PLANNED DEVELOPMENT
FINAL PLAN

▸ **FILE #:**	**11-A-26-PD**	**AGENDA ITEM #:** **18**
		AGENDA DATE: **11/12/2026**
▸ **APPLICANT:**	**AMY SHERRILL**	
OWNER(S):	Orel Brodt TFU Hamsa LLC	
TAX ID NUMBER:	109 K G 023	**View map on KGIS**
JURISDICTION:	City Council District 1	
STREET ADDRESS:	4333 GALBRAITH SCHOOL RD	
▸ **LOCATION:**	**Northeast side of Galbraith School Rd, southeast side of Decatur Dr**	
▸ **APPX. SIZE OF TRACT:**	**2.61 acres**	
SECTOR PLAN:	South City	
GROWTH POLICY PLAN:	N/A (Within City Limits)	
ACCESSIBILITY:	Access is via Galbraith School Road, a local street with a 21-ft pavement width within a right-of-way which varies from 40 ft to 50 ft.	
UTILITIES:	Water Source: Knoxville Utilities Board	
	Sewer Source: Knoxville Utilities Board	
FIRE DISTRICT:	Knoxville Fire Department	
WATERSHED:	Baker Creek	
▸ **ZONING:**	**RN-1 (Single-Family Residential Neighborhood)**	
▸ **EXISTING LAND USE:**	**Rural Residential**	
▸ **PROPOSED USE:**	**Final Plan for the adaptive reuse of Galbraith Elementary School campus for residences.**

▸ **Approve the final plan for the Galbraith School Adaptive Reuse Planned Development because it is in substantial conformance with the appro

LANDSCAPED AREA SITE PLAN A01

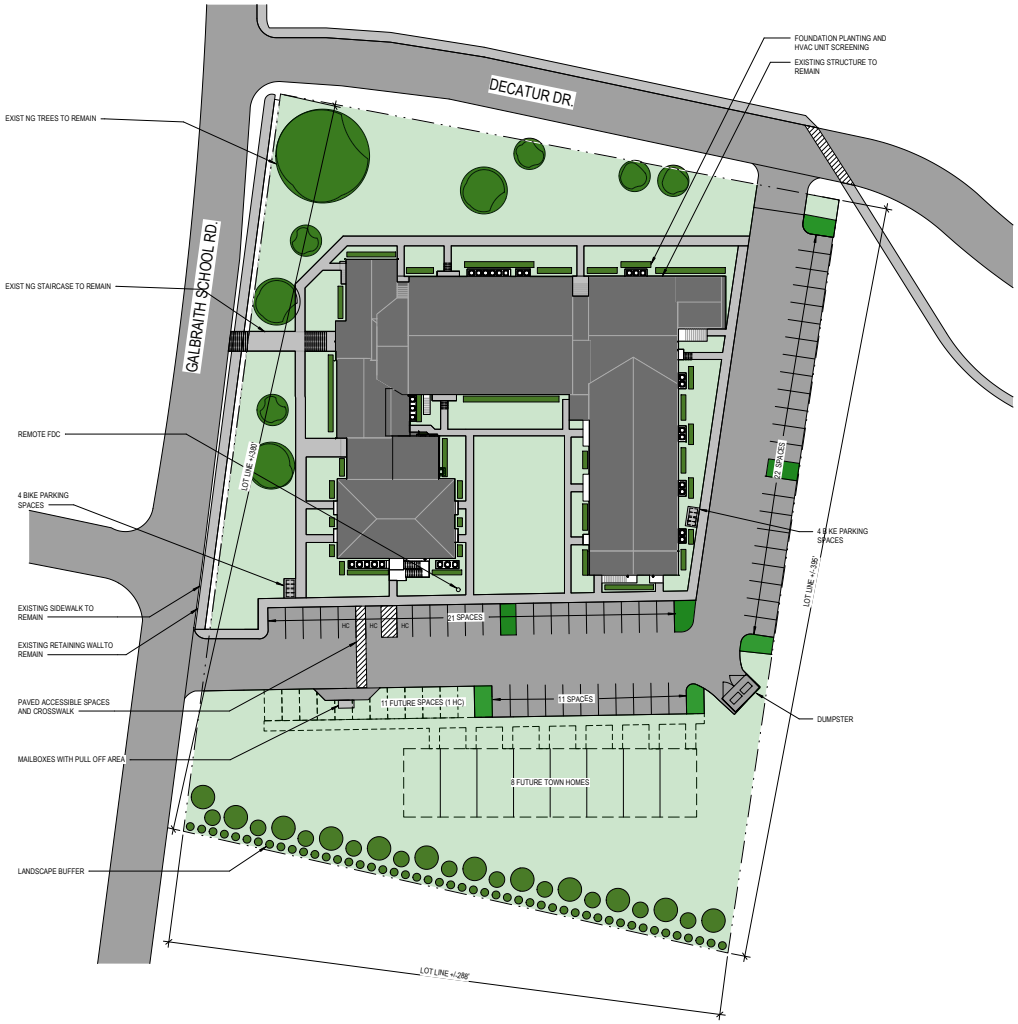
1. Increasing the impervious surface maximum in the RN-1 district from 40% to 51%
- The final plan shows no change to the 51% maximum impervious surface request, which includes the existing school, gravel parking lot for the multifamily development within the school, and area for the future townhouses. Total impervious surface coverage may increase as part of a secondary PD review for future parking and other aspects of the phase 2 townhouse development, but that is not within the scope of this review.
- Parking lot access to Decatur Drive was established in the final plan once legal access to this closed right-of-way was validated through the deed. The parking lot now has two possible access points, and sight distance evaluation with City Engineering is ongoing.

2. Permitting the use of multifamily and townhouse dwellings.
- The preliminary proposal was for 36 multifamily units, which has been reduced to 33 units in the final plan. There are still 8 townhouse units proposed.
- The bedroom distribution by unit was changed as follows:
  Preliminary: 24 x 1-bedroom units --> Final: 17 x 1-bedroom units
  Preliminary: 10 x 2-bedroom units --> Final: 14 x 2-bedroom units
  Preliminary: 2 x 3-bedroom units --> Final: no change
- The total number of parking spaces being considered as part of this PD was reduced from 66 to 54 spaces. Part of this reduction is the removal of townhouse parking from consideration in this review cycle. The 54 spaces provided meet the minimum parking requirements for the final proposed 33 multifamily units. Townhouse parking will be evaluated in a subsequent PD review.

4. Updates were also made to meet the following three conditions for preliminary approval:
- Accessible parking spaces on the otherwise gravel parking lot were paved.

- A crosswalk across the parking lot to the mailboxes and future townhouses was paved.
- A minimum of 10 feet of pavement was provided at the access points where the driveway meets the right-of-way to prevent gravel migration.
